ADDENDUM NO. 1

**Administration Building Renovation Re-bid
Compton Community College District**

tBP Project. No. 20987.00

tBP/ARCHITECTURE

E0-5

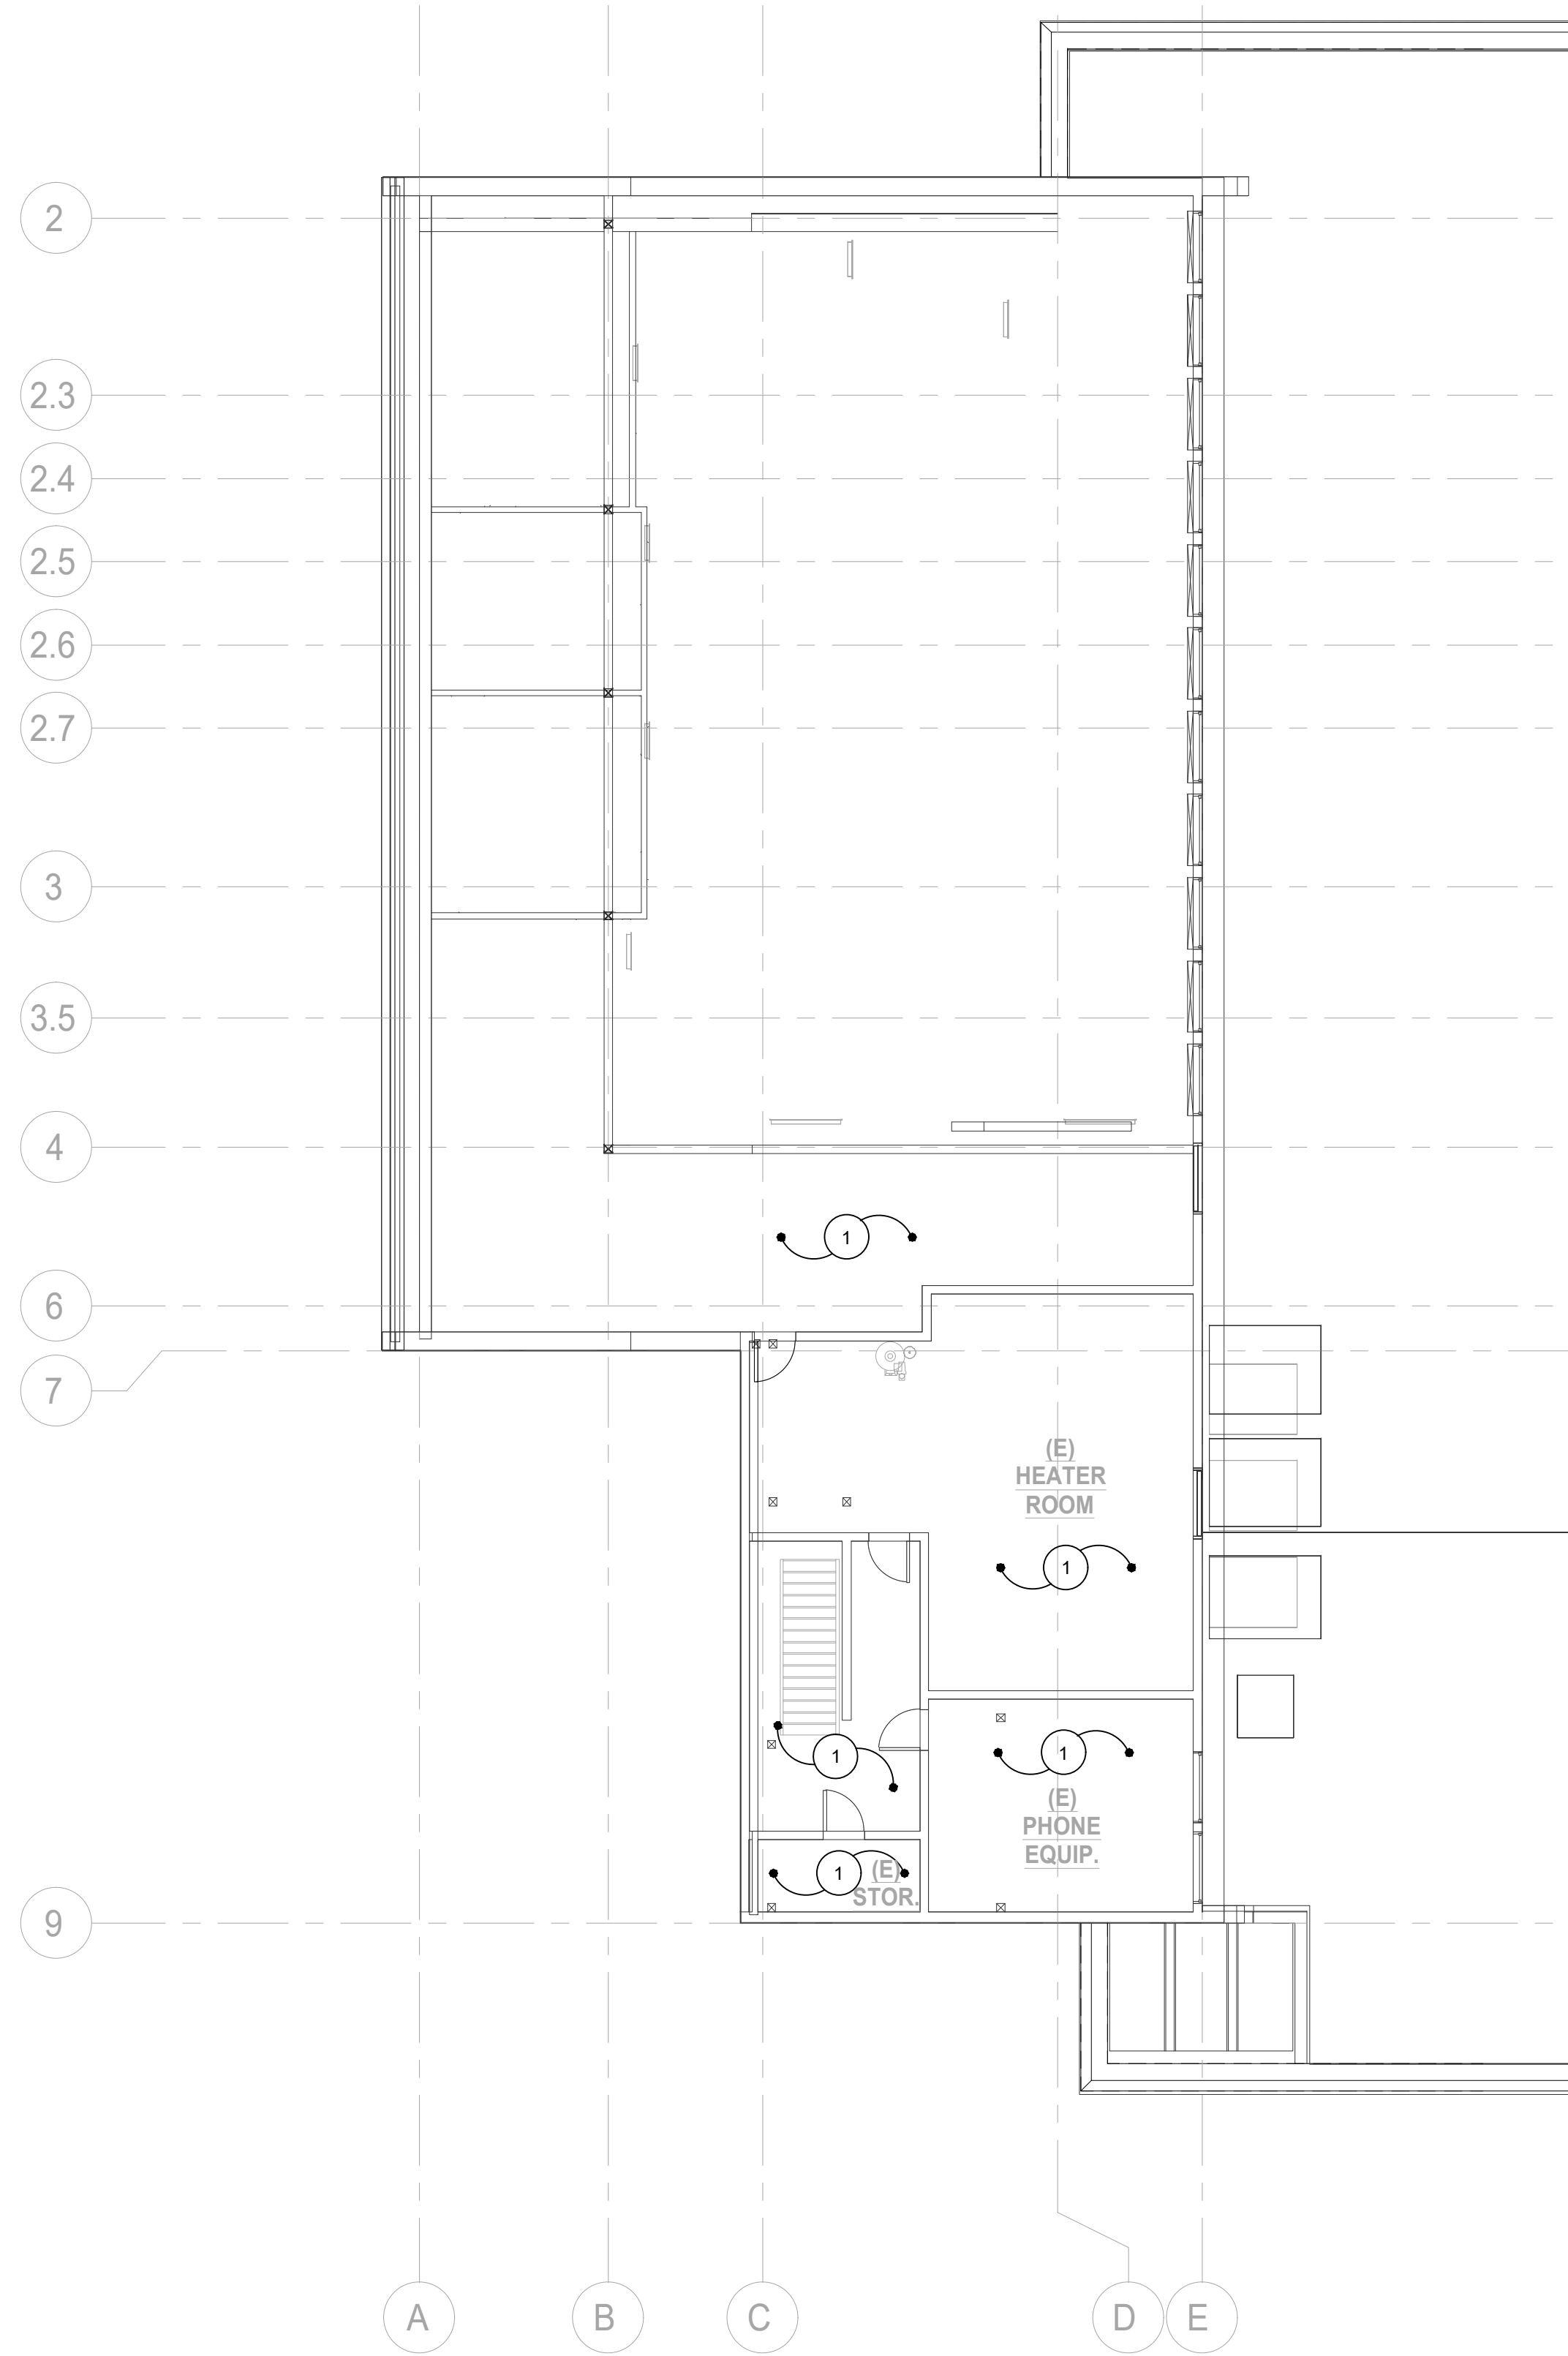
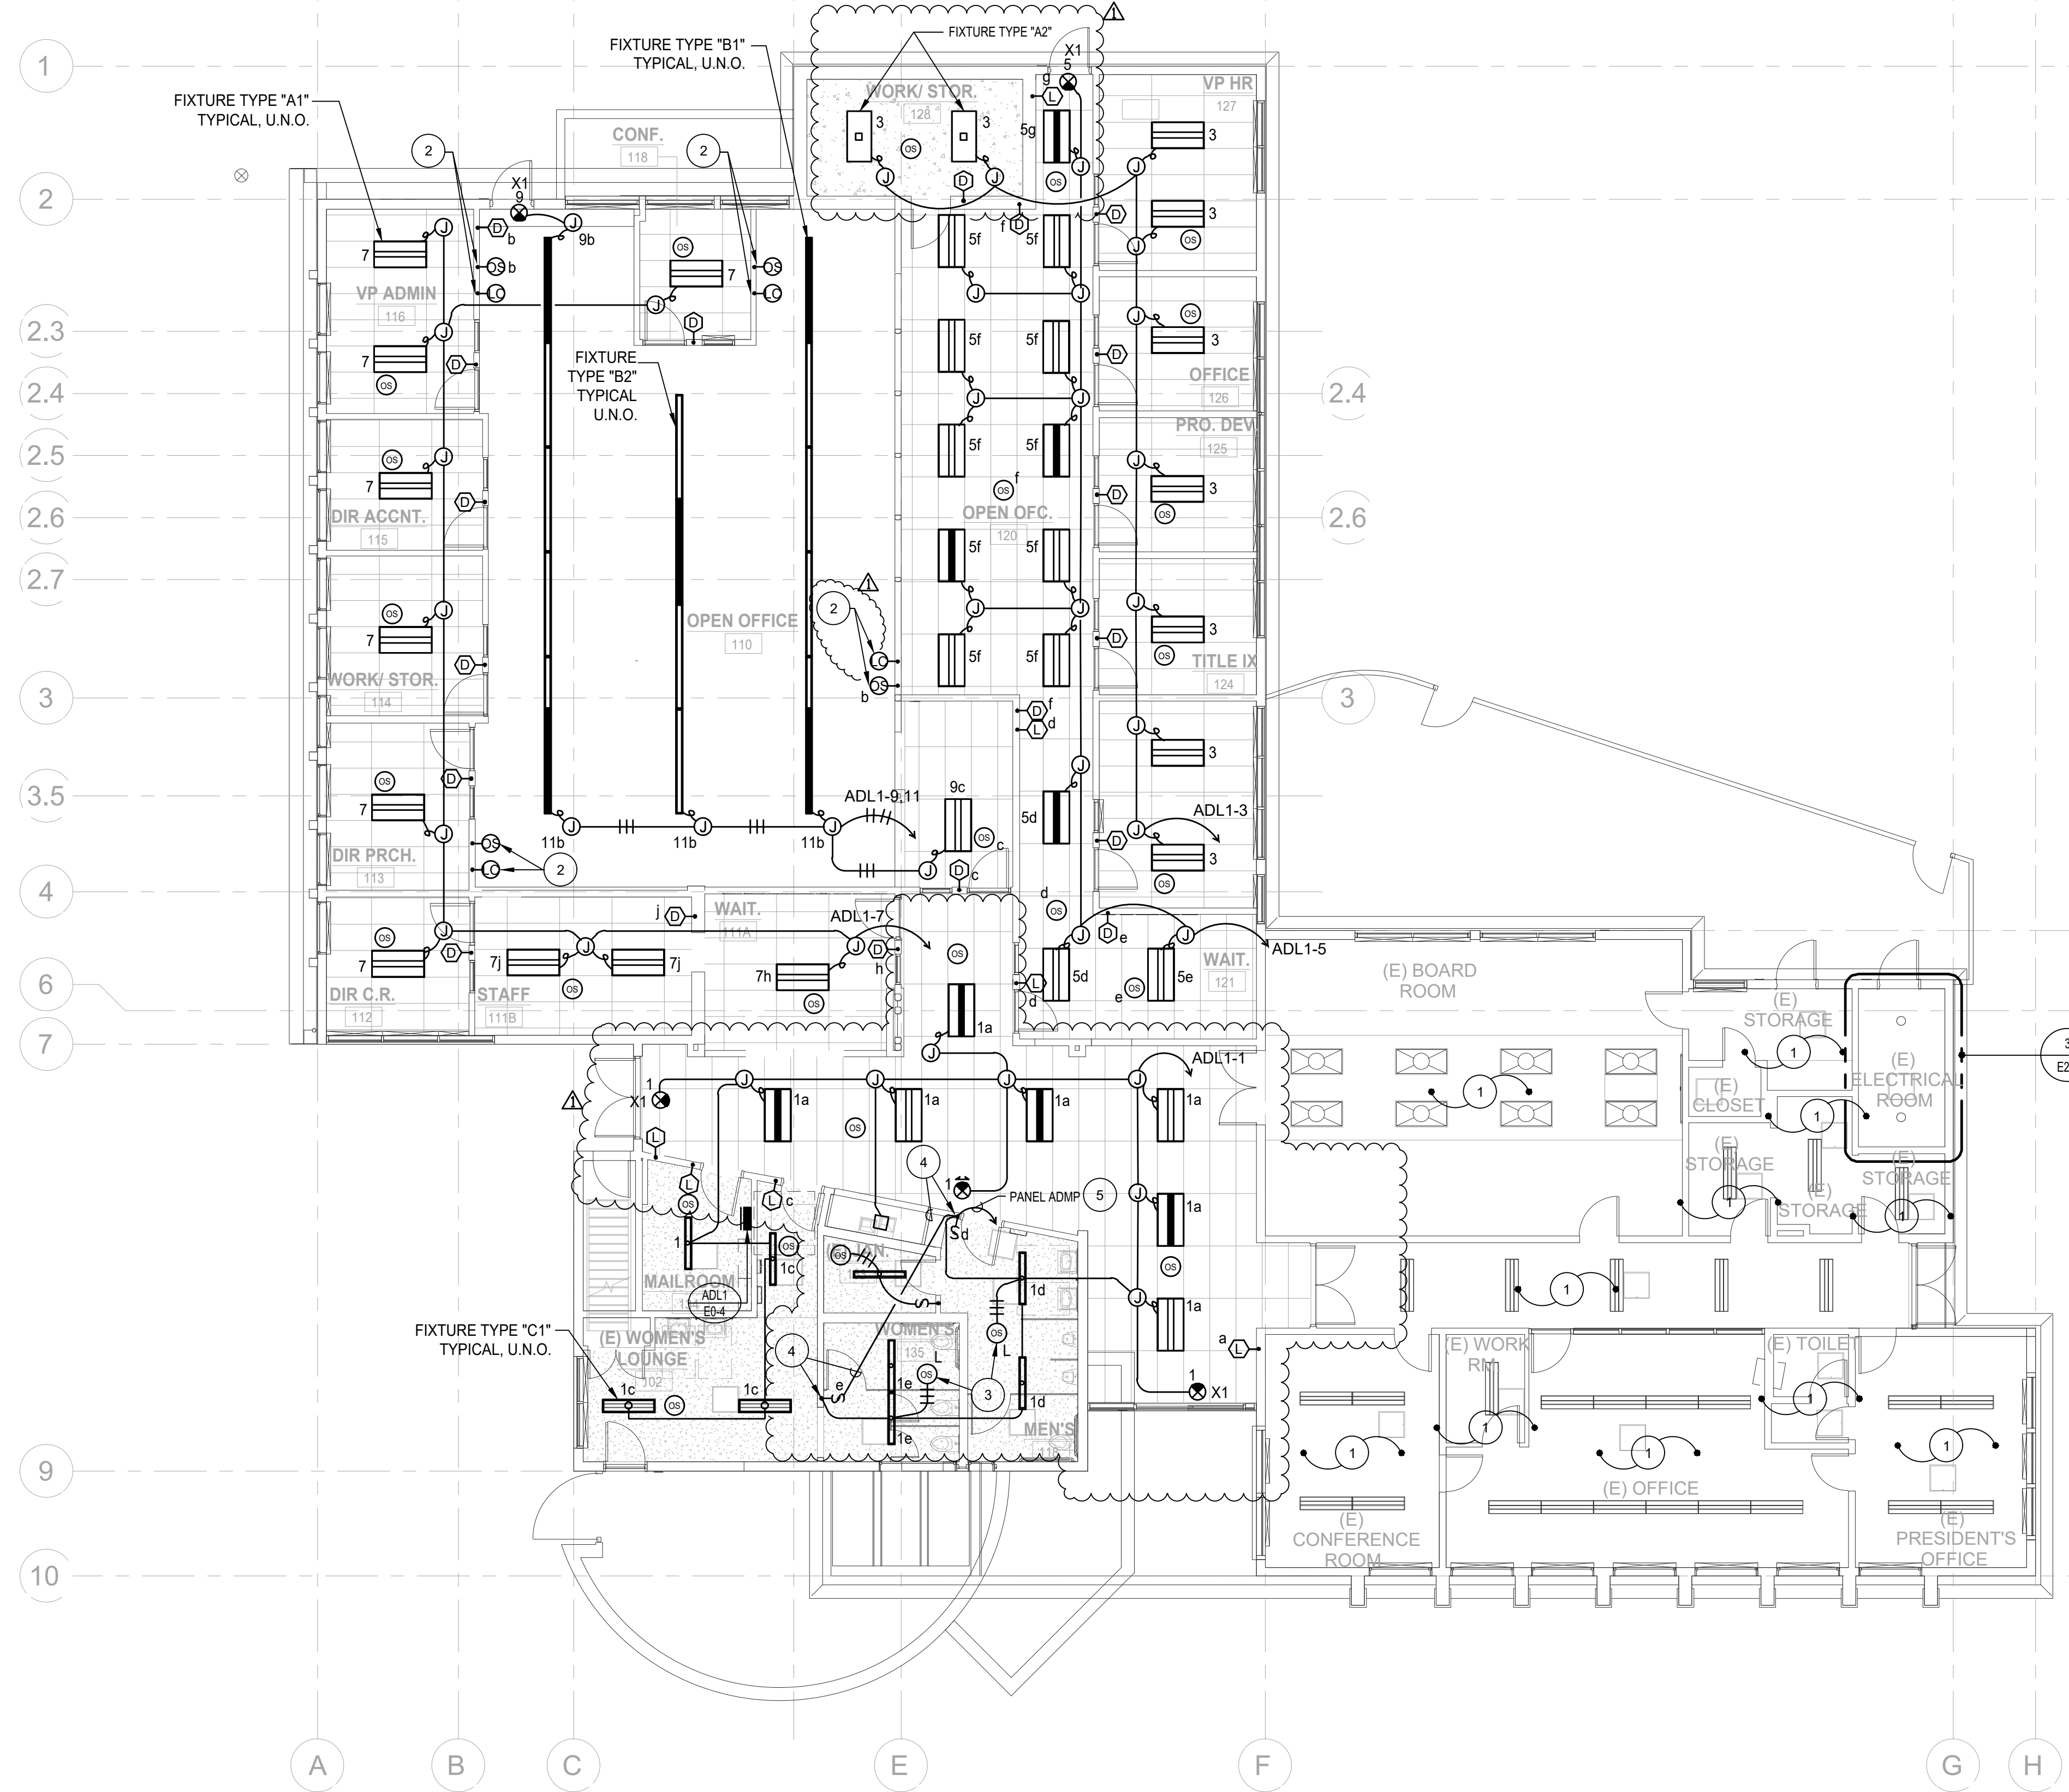
29. Revised Sheet E1-1 Lighting Plans

- a. Revised Lobby and Corridor Lighting Plans
- b. Revised Men and Women Restrooms Lighting Plans
